Jericho Wind, Inc.

Revision to the Design and Operations Report – Jericho Wind Energy Centre

September, 2013

Figure 2-1

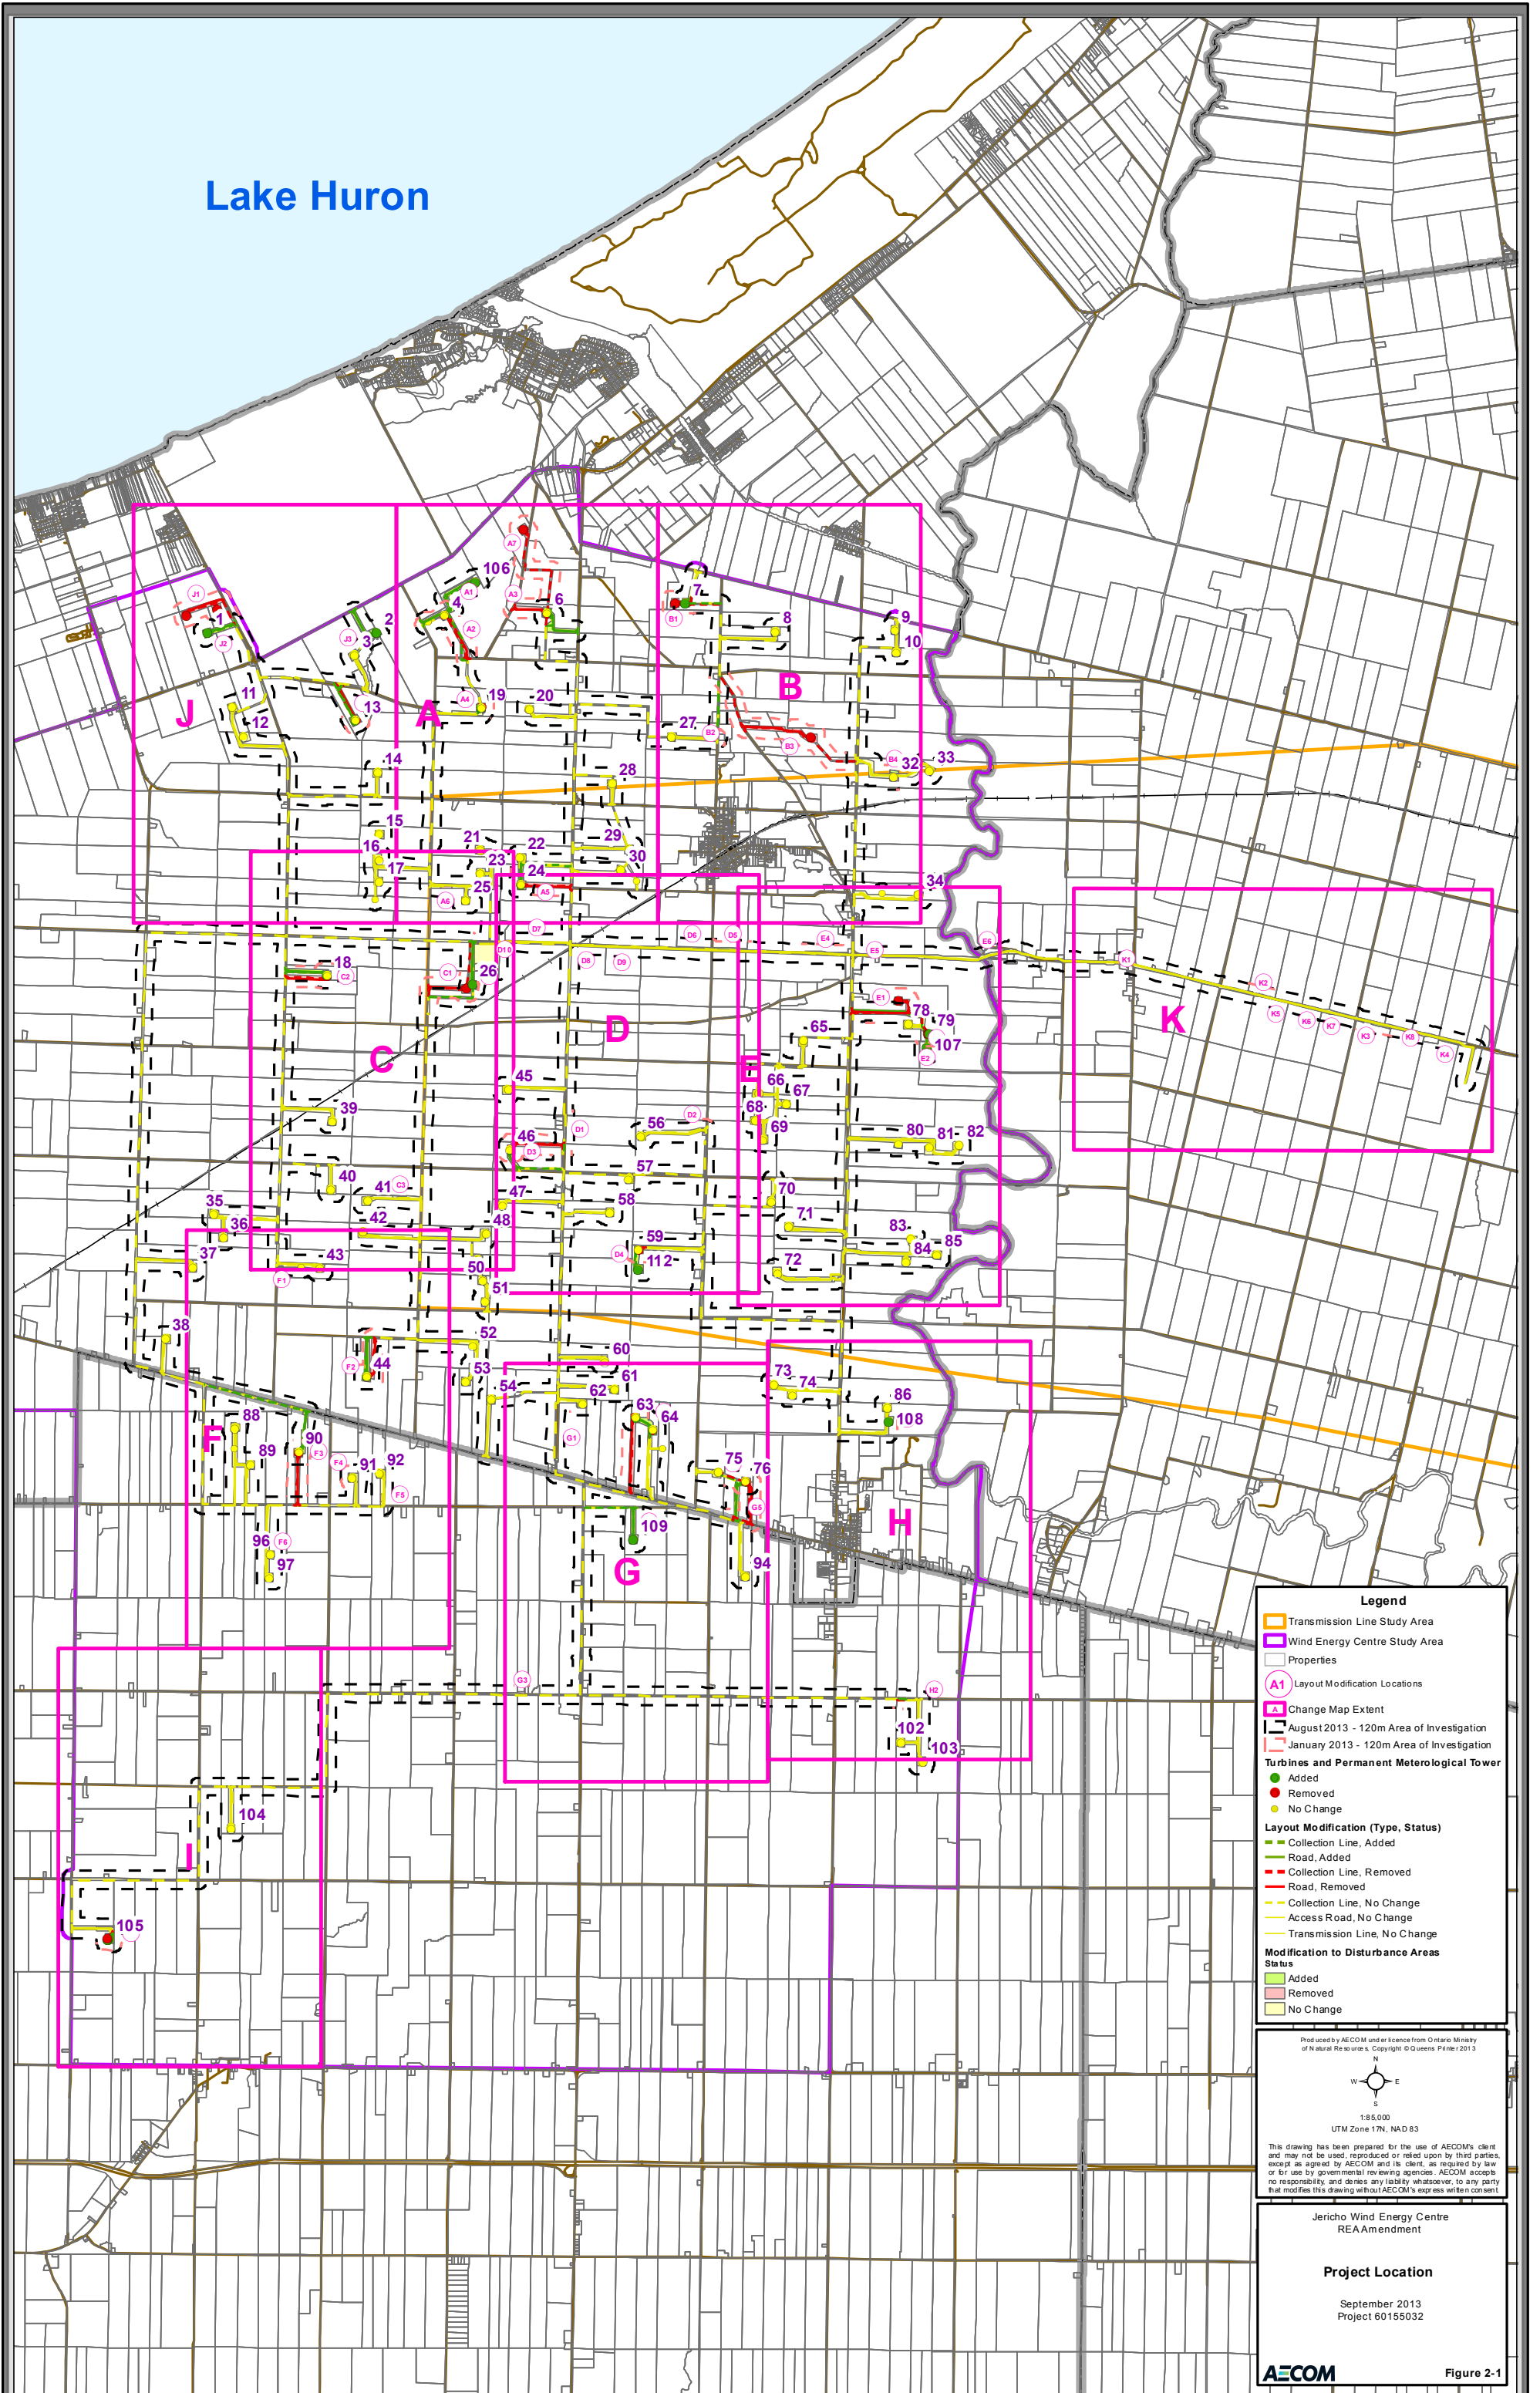
Figure 2-1 illustrates the modified Project Location. **Appendix A** contains a series of figures showing the details for each of the modifications.

| Label on Figure 2-1 | Proposed Modification | Rationale for Proposed Modification | New Potential Environmental Effects | New Mitigation Measures (Mitigation measures not included in the original REA are shown in <i>italicized bold</i>) |
|---------------------|--|--|--|---|
| A1 | Addition of Turbine 106 and associated access road and collection line, extending north east from Turbine 4. | Infrastructure or construction disturbance area added or changed to optimize project design/ constructability. | <p><u>Natural Heritage:</u></p> <ul style="list-style-type: none"> Access road is 24 m from a new Rare Vegetation Community Feature RVC-05 not previously described in the NHA. There are no potential effects to this feature associated with the access road during operation. Access road and collection line are within 120 m of new Generalized Candidate Significant Wildlife Habitat Feature (Insect Species of Conservation Concern Habitat, Plant Species of Conservation Concern Habitat, and Red-headed Woodpecker Habitat) in Natural Area 290, not previously described in the NHA. There are no potential effects on this feature associated with the access road and collection line during operation. <p><u>Water Bodies:</u></p> <ul style="list-style-type: none"> Effects associated with new crossing of a water body (Feature ID R4.16-D) include: <ul style="list-style-type: none"> Increase in impervious surfaces from presence of turbine foundation and access roads, resulting in increased water temperatures, increased surface runoff and stream peak flows, and reduced infiltration, base flows and upwelling. Soil/water contamination by oils, grease and other materials from accidental spills and release of contaminants from equipment. Obstruction of lateral flows in watercourses and other water bodies due to design of culverts and debris build-up at water crossings. | <p><u>Natural Heritage:</u></p> <ul style="list-style-type: none"> N/A <p><u>Water Bodies:</u></p> <ul style="list-style-type: none"> Regularly maintain vehicles and other equipment. Minimize vehicle traffic on exposed soils and sensitive slopes. Locate facilities where contaminants are handled at least 30 m away from water bodies. Develop and implement an erosion and sediment control plan. Develop a spill response plan. Control soil / water contamination through best management practices. Design culverts to accommodate high flows of the watercourse. Inspect culverts during routine maintenance activities for buildup of debris. |
| A2 | Relocation of access road to Turbine 4 to travel north east from Jericho Road, and relocation of collection line to Turbine 4 near Kennedy Line. | Construction disturbance area modified to reduce or eliminate impacts to archaeological resources. | None – no new natural heritage or water body features within 120 m; area previously studied for cultural heritage. | N/A |
| A3 | Relocation of access road and collection line to Turbine 6 to travel west from Northville Road and then north to Turbine 6; relocation of Turbine 6 construction disturbance area to the north. | Construction disturbance area modified to reduce or eliminate impacts to archaeological resources. | None – no new natural heritage or water body features within 120 m; area previously studied for cultural heritage. | N/A |
| A4 | Relocation of Turbine 19 construction disturbance area 19 m to the southwest and addition of access road construction disturbance area near Jericho Road. | Construction disturbance area modified to reduce or eliminate impacts to archaeological resources. | None – no new natural heritage or water body features within 120 m; area previously studied for cultural heritage. | N/A |
| A5 | Removal of access road and collection line to Turbine 24, addition of access road disturbance area between Turbine 22 and Turbine 24 and relocation of collection line to the access road disturbance area for Turbine 22. | Infrastructure or construction disturbance area added or changed to optimize project design/ constructability. | None – no new natural heritage or water body features within 120 m; area previously studied for cultural heritage. | N/A |
| A6 | Removal of a portion of construction disturbance area for access road and collection line to Turbines 21, 23 and 25. | Construction disturbance area modified to reduce or eliminate impacts to archaeological resources. | None – no new natural heritage or water body features within 120 m; area previously studied for cultural heritage. | N/A |
| A7 | Removal of Turbine 5 and associated access road and collection line. | Turbine and associated infrastructure removed. | None – no new natural heritage or water body features within 120 m; area previously studied for cultural heritage. | N/A |
| B1 | Relocation of Turbine 7 and associated construction disturbance area 148 m to the east. | Infrastructure or construction disturbance area added or changed to optimize project design/ constructability. | None – no new natural heritage or water body features within 120 m; area previously studied for cultural heritage. | N/A |
| B2 | Addition of collection line in Gordon Road right-of-way, north of the road to Turbine 27. | Infrastructure or construction disturbance area added or changed to optimize project design/ constructability. | <p><u>Natural Heritage:</u></p> <ul style="list-style-type: none"> Collection line is within 120 m of new Generalized Candidate Significant Wildlife Habitat Feature (Plant Species of Conservation Concern Habitat and Red-headed Woodpecker Habitat) in Natural Area 233, not previously described in the NHA. There are no potential effects on this feature associated with the collection line during operation. | <p><u>Natural Heritage:</u></p> <ul style="list-style-type: none"> N/A |
| B3 | Removal of Turbine 31 and associated access road and collection line. | Turbine and associated infrastructure removed. | <p><u>Natural Heritage:</u></p> <ul style="list-style-type: none"> Amphibian Woodland Breeding Habitat Feature AWO-16 in Natural Area 250 was changed to Generalized Candidate Significant Wildlife Habitat because it is more than 120 m away from a proposed access road. There are no potential effects on this feature associated with operation of the project. | N/A |
| B4 | Addition of Turbine 32 construction disturbance area 34 m to the north and removal of the southeast portion of construction disturbance area. | Construction disturbance area modified to reduce or eliminate impacts to archaeological resources. | None – no new natural heritage or water body features within 120 m; area previously studied for cultural heritage. | N/A |

| Label on Figure 2-1 | Proposed Modification | Rationale for Proposed Modification | New Potential Environmental Effects | New Mitigation Measures (Mitigation measures not included in the original REA are shown in <i>italicized bold</i>) |
|---------------------|--|--|--|---|
| C1 | Relocation of Turbine 26 and associated construction disturbance area 101 m east. Access road relocated to travel north through the substation construction disturbance area and collection line relocated to the southern property boundary; and addition of construction disturbance area in Thompson Line right-of-way. | Infrastructure or construction disturbance area added or changed to optimize project design/ constructability. | <p><u>Water Bodies:</u></p> <ul style="list-style-type: none"> • Effects associated with new crossing of a water body (Feature ID R4.16-A) include: <ul style="list-style-type: none"> • Increase in impervious surfaces from presence of access road, resulting in increased water temperatures, increased surface runoff and stream peak flows, and reduced infiltration, base flows and upwelling. • Soil/water contamination by oils, grease and other materials from maintenance activities. <p><u>Natural Heritage:</u></p> <ul style="list-style-type: none"> • Generalized Candidate Significant Wildlife Habitat in Natural Area 173 was changed to Amphibian Woodland Breeding Habitat Feature AWO-22¹ because it is >0.1 m from a proposed access road. New potential effects on this feature associated with the access road during operation include: <ul style="list-style-type: none"> • Risk of road mortality to amphibians moving between breeding pools and home range. • Amphibian Woodland Breeding Habitat Feature AWO-20 in Natural Area 172 was changed to Generalized Candidate Significant Wildlife Habitat because it is more than 120 m away from a proposed access road. There are no potential effects on this feature associated with operation of the project. • Collection line is within 120 m of new Generalized Candidate Significant Wildlife Habitat Feature (Plant Species of Conservation Concern Habitat) in Natural Area 172, not previously described in the NHA. There are no potential effects on this feature associated with the collection line during operation. | <p><u>Water Bodies:</u></p> <ul style="list-style-type: none"> • Locate facilities where contaminants are handled at least 30 m away from water bodies. • Develop and implement an erosion and sediment control plan. • Develop a spill response plan. • Control soil / water contamination through best management practices. <p><u>Natural Heritage:</u></p> <ul style="list-style-type: none"> • For operation of the access road within >0.1 m of Amphibian Woodland Breeding Habitat Feature AWO-22: <ul style="list-style-type: none"> • Advise operations staff to avoid driving roads in proximity to this feature at night between April 1 and June 30, and any rainy nights from spring to early autumn, wherever possible. • Maintain wildlife crossing signs and limit speed of vehicles near crossings (30 km/hr). • Conduct 3 years post-construction amphibian call surveys (frogs and toads) and egg mass or adult surveys (salamanders) to assess any potential changes in amphibian breeding populations or species distribution (if feature determined to be significant) by a qualified Biologist, using the protocol described in Section 4.3.2.1 of the NHA. • Report the findings of post-construction monitoring to MNR on an annual basis for the first 3 years of operation. • Contingency Measure: If significant declines or disappearance of species is detected, determine whether likely to have been caused by the Project. If so, corrective measures will be taken, to be determined through consultation with MNR. |
| C2 | Relocation of access road to Turbine 18 31 m to the north. | Construction disturbance area modified to reduce or eliminate impacts to archaeological resources. | None – no new natural heritage or water body features within 120 m; area previously studied for cultural heritage. | N/A |
| C3 | Addition of construction disturbance area for access road and collection line to Turbine 41. | Infrastructure or construction disturbance area added or changed to optimize project design/ constructability. | None – no new natural heritage or water body features within 120 m; area previously studied for cultural heritage. | N/A |
| C4 | Addition of a spare 170 mVA transformer (XMR) to be stored within the existing footprint of the Jericho substation. | Infrastructure or construction disturbance area added or changed to optimize project design/ constructability. | No new potential environmental effects as the transformer will be used as a backup for the primary transformer. | N/A |
| D1 | Addition of construction disturbance area in the Northville Road right-of-way in two locations for collection line between Turbines 45 and 46. | Infrastructure or construction disturbance area added or changed to optimize project design/ constructability. | None – no new natural heritage or water body features within 120 m; area previously studied for cultural heritage. | N/A |
| D2 | Removal of a portion of construction disturbance area for access road and collection line to Turbine 56. | Construction disturbance area modified to reduce or eliminate impacts to archaeological resources. | None – no new natural heritage or water body features within 120 m; area previously studied for cultural heritage. | N/A |
| D3 | Relocation of Turbine 46 access road to travel north from Cedar Point Line and collection to travel east along the southern property boundary; and addition of construction disturbance area for collection line in the Northville Road right-of-way. | Construction disturbance area modified to reduce or eliminate impacts to archaeological resources. | <p><u>Water Bodies:</u></p> <ul style="list-style-type: none"> • Effects associated with water body present in 120 m buffer for access road and collection line (Feature ID R4E and R4D) include: <ul style="list-style-type: none"> • Increase in impervious surfaces from presence of access road, resulting in increased water temperatures, increased surface runoff and stream peak flows, and reduced infiltration, base flows and upwelling. | N/A |
| D4 | Addition of Turbine 112 and associated access road and collection line, extending south from Turbine 59. | Infrastructure or construction disturbance area added or changed to optimize project design/ constructability. | <p><u>Natural Heritage:</u></p> <ul style="list-style-type: none"> • Turbine construction disturbance area is within 120 m of a new Generalized Candidate Significant Wildlife Habitat Feature (Plant Species of Conservation Concern Habitat and Red-headed Woodpecker Habitat) in Natural Area 145, not previously described in the NHA. There are no potential effects on this feature associated with operation of the turbine. | N/A |
| D5 | Addition of construction disturbance area on private property to the north of Thompson Line to allow for installation of collection line and/or transmission line. | Infrastructure or construction disturbance area added or changed to optimize project design/ constructability. | None – no new natural heritage or water body features within 120 m; area previously studied for cultural heritage. | N/A |
| D6 | Addition of transmission line construction disturbance area on private property to allow for transmission line installation either in the Thompson Line right-of-way or on private property, within the disturbance area proposed to host collection line. | Infrastructure or construction disturbance area added or changed to optimize project design/ constructability. | None – no new natural heritage or water body features within 120 m; area previously studied for cultural heritage. | N/A |

| Label on Figure 2-1 | Proposed Modification | Rationale for Proposed Modification | New Potential Environmental Effects | New Mitigation Measures (Mitigation measures not included in the original REA are shown in <i>italicized bold</i>) |
|---------------------|---|--|---|--|
| D7 | Addition of collection line disturbance area on private property to allow for collection line installation either in the Thompson Line right-of-way or on private property, within the disturbance area proposed to host the transmission line. | Infrastructure or construction disturbance area added or changed to optimize project design/ constructability. | None – no new natural heritage or water body features within 120 m; area previously studied for cultural heritage. | N/A |
| D8 | Addition of collection line disturbance area on private property to allow for collection line installation either in the Thompson Line right-of-way or on private property, within the disturbance area proposed to host the transmission line. | Infrastructure or construction disturbance area added or changed to optimize project design/ constructability. | None – no new natural heritage or water body features within 120 m; area previously studied for cultural heritage. | N/A |
| D9 | Addition of collection line disturbance area on private property to allow for collection line installation either in the Thompson Line right-of-way or on private property, within the disturbance area proposed to host the transmission line. | Infrastructure or construction disturbance area added or changed to optimize project design/ constructability. | None – no new natural heritage or water body features within 120 m; area previously studied for cultural heritage. | N/A |
| D10 | Relocation of transmission line construction disturbance area within natural areas located in the Thompson Line right-of-way. | Infrastructure or construction disturbance area added or changed to optimize project design/ constructability. | <u>Natural Heritage:</u> <ul style="list-style-type: none"> The transmission line is proposed in Significant Woodland Feature WOD-201. New potential effects on this feature associated with the transmission line during operation include: <ul style="list-style-type: none"> Risk of soil or water contamination from oil, gas, etc. during maintenance activities. | <u>Natural Heritage:</u> <ul style="list-style-type: none"> For operation of the transmission line within Significant Woodland Feature WOD-201: <ul style="list-style-type: none"> Develop and implement an emergency spills plan outlining steps to contain any spills during maintenance activities to avoid contamination of significant woodland. Contingency Measure: Report the details of the spill to MOE, including a description of any assessment and remediation undertaken. |
| E1 | Removal of Turbine 77 and associated access road and collection line / Removal and addition of portions of construction disturbance area for access road and collection line to Turbines 78, 79 and 107. | Turbine and associated infrastructure removed / Construction disturbance area modified to reduce or eliminate impacts to archaeological resources. | None – no new natural heritage or water body features within 120 m; area previously studied for cultural heritage. | N/A |
| E2 | Addition of Turbine 107 and associated access road and collection line, extending south from Turbine 79. | Infrastructure or construction disturbance area added or changed to optimize project design/ constructability. | None – no new natural heritage or water body features within 120 m; area previously studied for cultural heritage. | N/A |
| E3 | Relocation of Turbine 79 23 m to the east, within existing turbine construction disturbance area. | Construction disturbance area modified to reduce or eliminate impacts to archaeological resources. | None – no new natural heritage or water body features within 120 m; area previously studied for cultural heritage. | N/A |
| E4 | Addition of construction disturbance area on private property to the north of Thompson Line to allow for installation of collection line and/or transmission line. | Infrastructure or construction disturbance area added or changed to optimize project design/ constructability. | None – no new natural heritage or water body features within 120 m; area previously studied for cultural heritage. | N/A |
| E5 | Relocation of transmission line construction disturbance area within natural areas located in the Thompson Line road right-of-way. | Infrastructure or construction disturbance area added or changed to optimize project design/ constructability. | None – no new natural heritage or water body features within 120 m; area previously studied for cultural heritage. | N/A |
| E6 | Relocation of transmission line construction disturbance area within natural areas located in the Thompson Line/Elginfield Road right-of-way. | Infrastructure or construction disturbance area added or changed to optimize project design/ constructability. | <u>Natural Heritage:</u> <ul style="list-style-type: none"> The transmission line is proposed in Significant Wetland Feature WET-050. New potential effects on this feature associated with the transmission line during operation include: <ul style="list-style-type: none"> Trimming of branches or selective tree removal during routine maintenance of the transmission line in Significant Wetland WET-050. | <u>Natural Heritage:</u> <ul style="list-style-type: none"> For operation of the transmission line in Significant Wetland Feature WET-050: <ul style="list-style-type: none"> Minimize vegetation removal in Significant Wetland, to the extent possible. Perform routine vegetation clearing outside of the breeding season for birds and amphibians (March 15 to July 31). If this is not possible, MNR will be consulted regarding mitigation measures that may be required. Remove trees or tree limbs by hand-held equipment within Significant Wetland to minimize soil compaction. Fell trees with a chainsaw away from the Significant Wetland to reduce damage to adjacent vegetation being retained. Carry out removal of tree limbs under supervision of an Arborist or Forester. Leave tree stumps and roots in place, to minimize disturbance to adjacent vegetation. Contingency Measure: Any damaged trees will be pruned through implementation of proper arboricultural techniques, under supervision of an Arborist or Forester. |
| F1 | Removal of a portion of construction disturbance area for access road and collection line to Turbine 43. | Construction disturbance area modified to reduce or eliminate impacts to archaeological resources. | None – no new natural heritage or water body features within 120 m; area previously studied for cultural heritage. | N/A |

| Label on Figure 2-1 | Proposed Modification | Rationale for Proposed Modification | New Potential Environmental Effects | New Mitigation Measures (Mitigation measures not included in the original REA are shown in <i>italicized bold</i>) |
|---------------------|---|--|--|---|
| F2 | Relocation of Turbine 44 access road 32 m to the west. | Construction disturbance area modified to reduce or eliminate impacts to archaeological resources. | <p><u>Natural Heritage:</u></p> <ul style="list-style-type: none"> Access road is 41 m from a new Significant Woodland Feature WOD-011, not previously described in the NHA. There are no potential effects to this feature associated with the access road during operation. Access road is within 120 m of new Generalized Candidate Significant Wildlife Habitat Feature (Plant Species of Conservation Concern Habitat) in Natural Area 117, not previously described in the NHA. There are no potential effects on this feature associated with the access road during operation. Access road is within 120 m of new Generalized Candidate Significant Wildlife Habitat Feature (Plant Species of Conservation Concern Habitat and Red-headed Woodpecker Habitat) in Natural Area 383, not previously described in the NHA. There are no potential effects on this feature associated with the access road during operation. | N/A |
